redline Appert
2023.06.02

DIMENSIONS ARE IN INCHES		NOTES AND TOLERANCES: (UNLESS OTHERWISE SPECIFIED)		LIGO CALIFORNIA INSTITUTE OF TECHNOLOGY MASSACHUSETTS INSTITUTE OF TECHNOLOGY		PART NAME aLIGO TCS UPPER MONOLITHIC RH SHIELD	
TOLERANCES: .XX ± .01 .XXX ± .005		1. INTERPRET DRAWING PER ASME Y14.5-1994. 2. REMOVE ALL SHARP EDGES, R.02 MIN. 3. DO NOT SCALE FROM DRAWING. 4. ALL MACHINING FLUIDS MUST BE FULLY SYNTHETIC, FULLY WATER SOLUBLE AND FREE OF SULFUR, SILICONE, AND CHLORINE.		SYSTEM ADVANCED LIGO		SUB-SYSTEM AOS	
ANGULAR ± 1.0°		MATERIAL 6061 Alloy		FINISH 32 μinch		NEXT ASSY D1001838	
				DESIGNER M. JACOBSON		21 APR 2010	
				DRAFTER A. COLE		7/13/2010	
				CHECKER M. JACOBSON		9/22/2011	
				APPROVAL A. BROOKS		9/23/2011	
				SIZE D		DWG. NO. D1001679	
				SCALE: 1:2		PROJECTION:	
						SHEET 1 OF 2	
						REV. v6

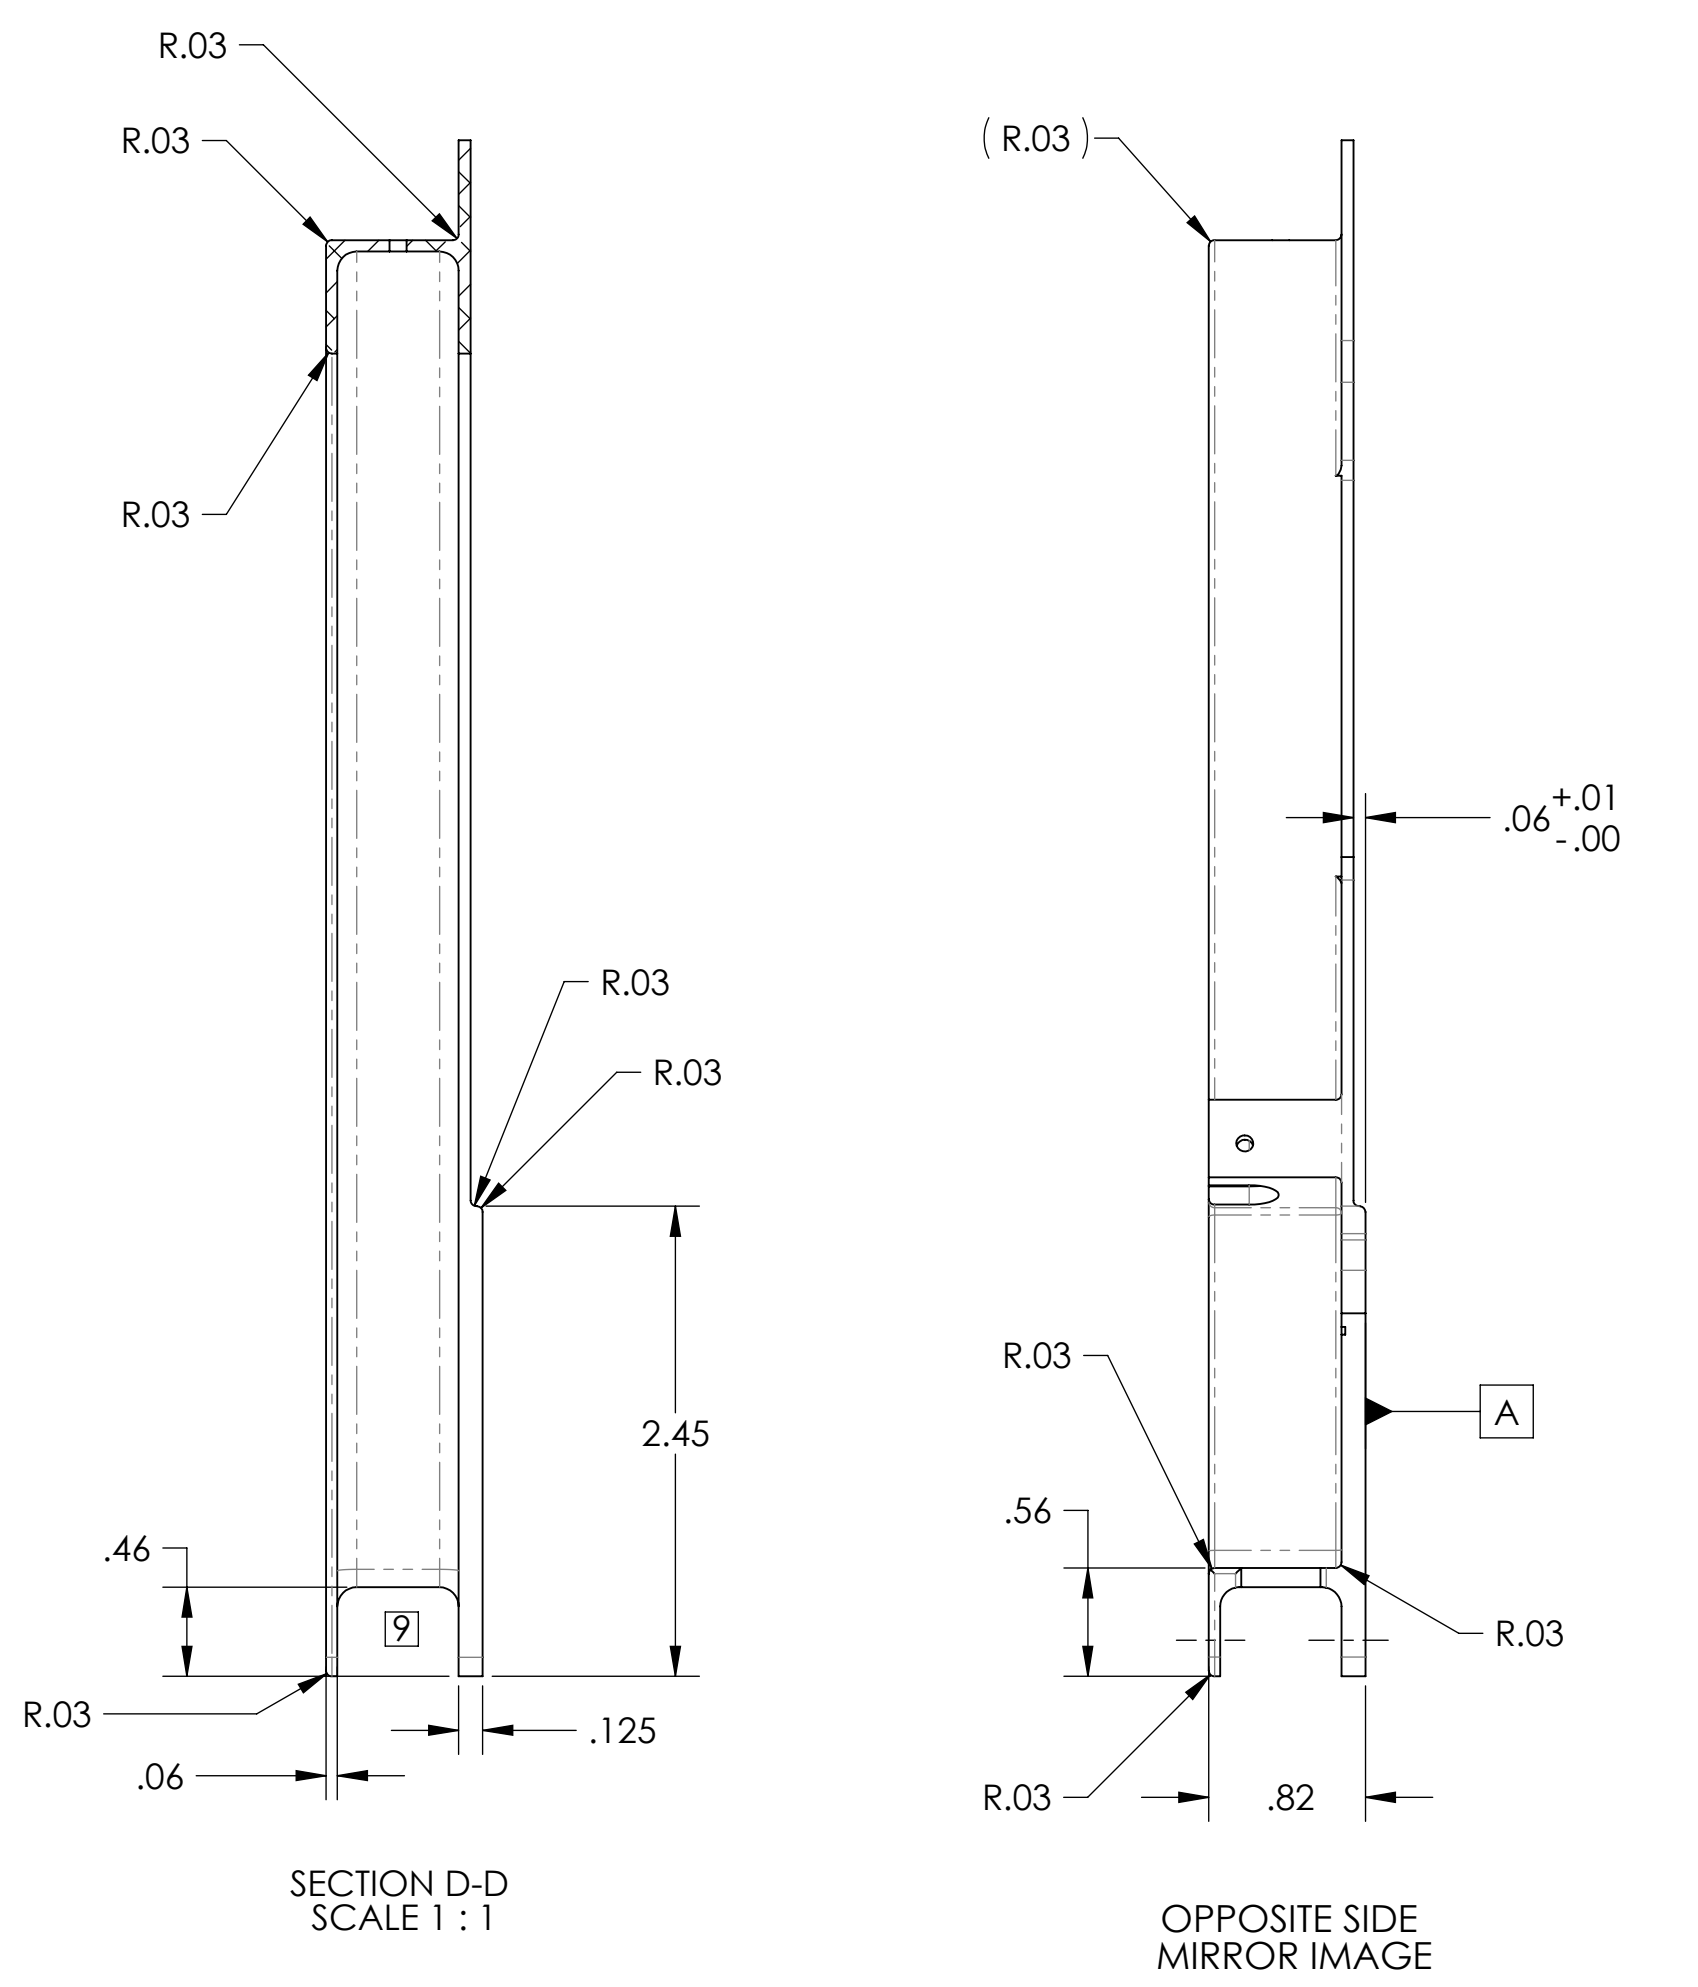
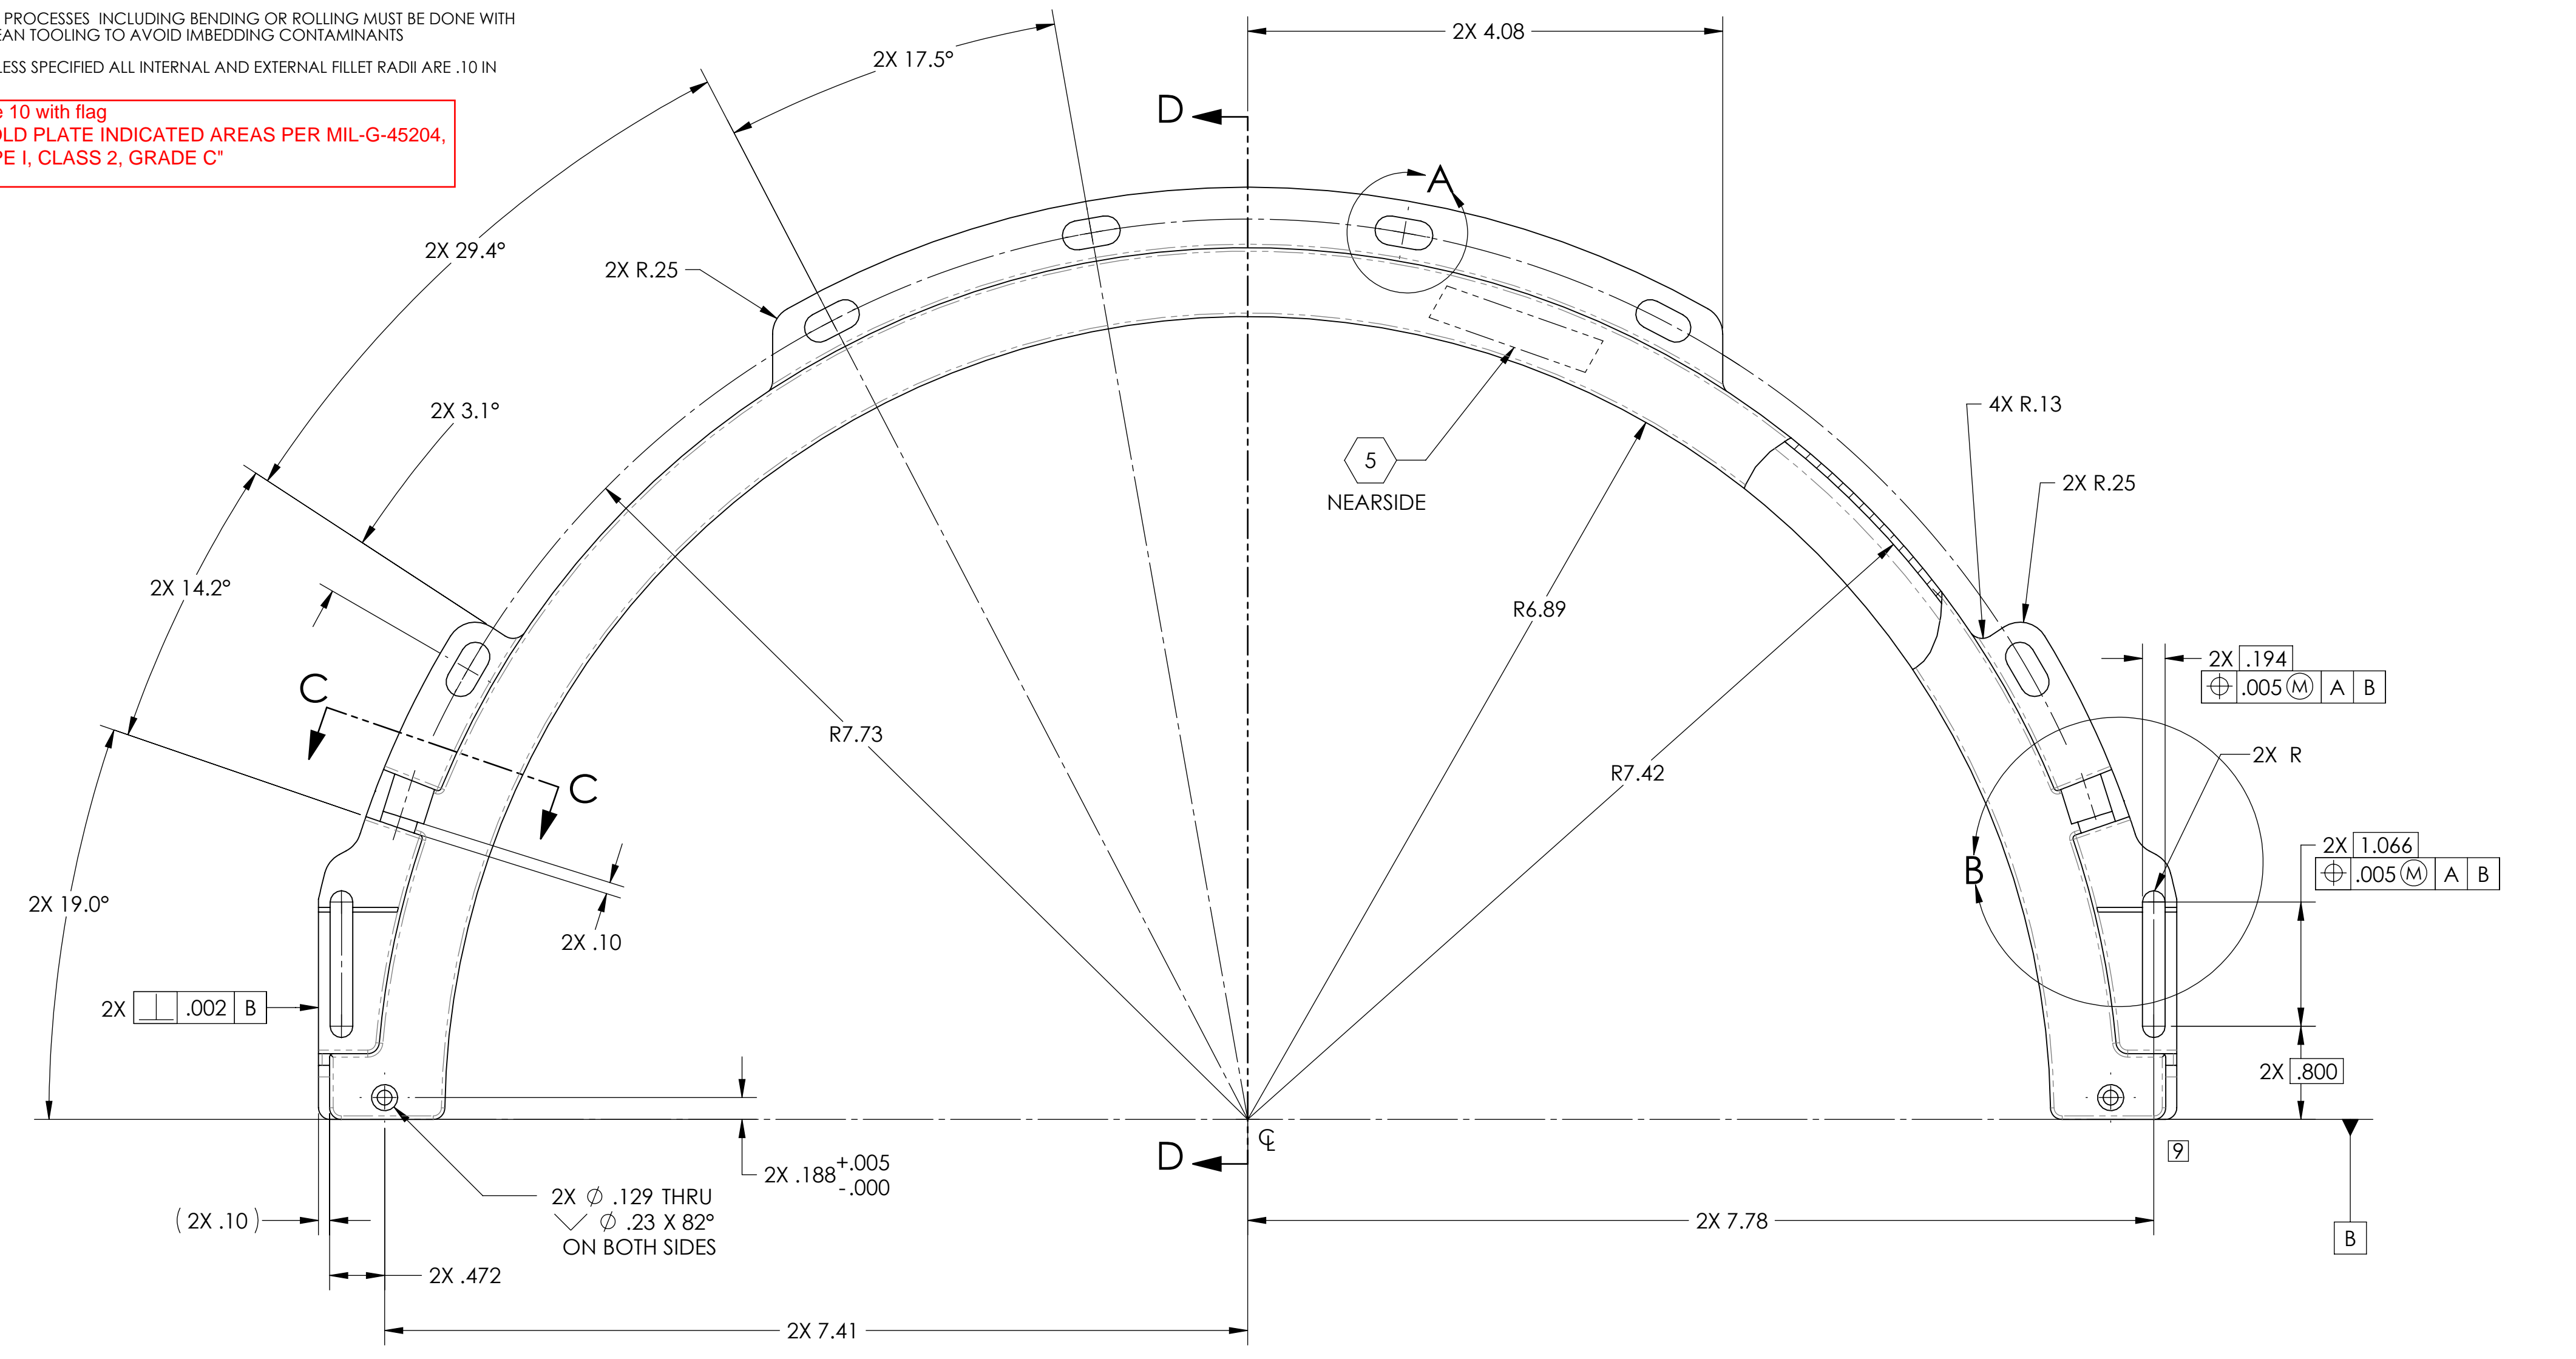
note 10 with flag
"GOLD PLATE INDICATED AREAS PER MIL-G-45204, TYPE I, CLASS 2, GRADE C"

move to note, add flag

TYPE 1 GOLD PLATING PER MIL-G-45204
INTERIOR SURFACES ONLY

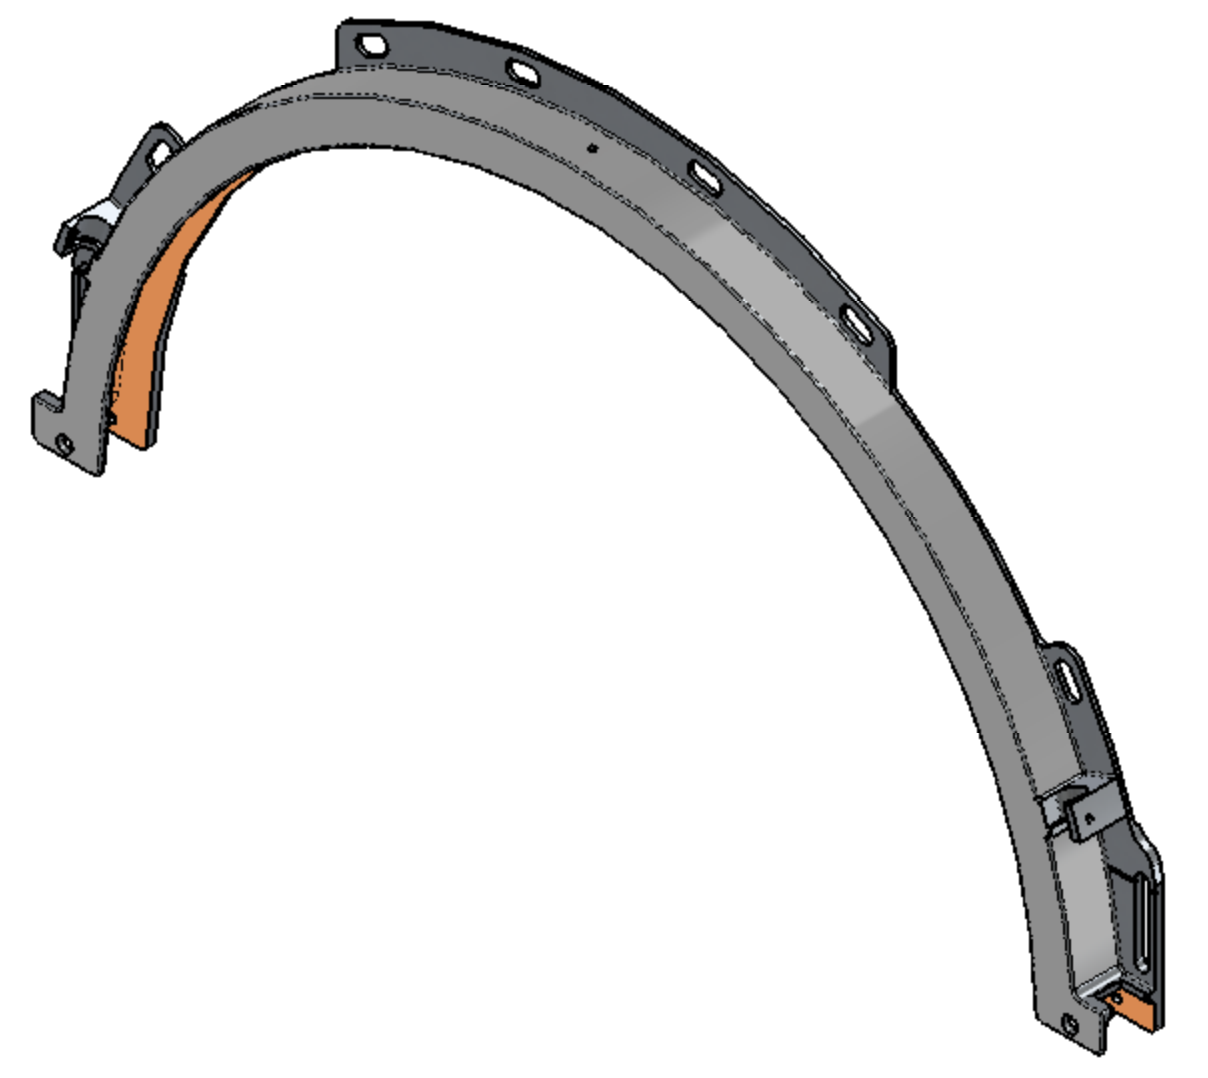
#4-40, .005 OVERSIZED
DRILL AND TAP THRU ALL

callout per ligo spec - use standard SW callout to generate size and tolerance for pilot drill, reference UNC; then, add "H11 (+.005)
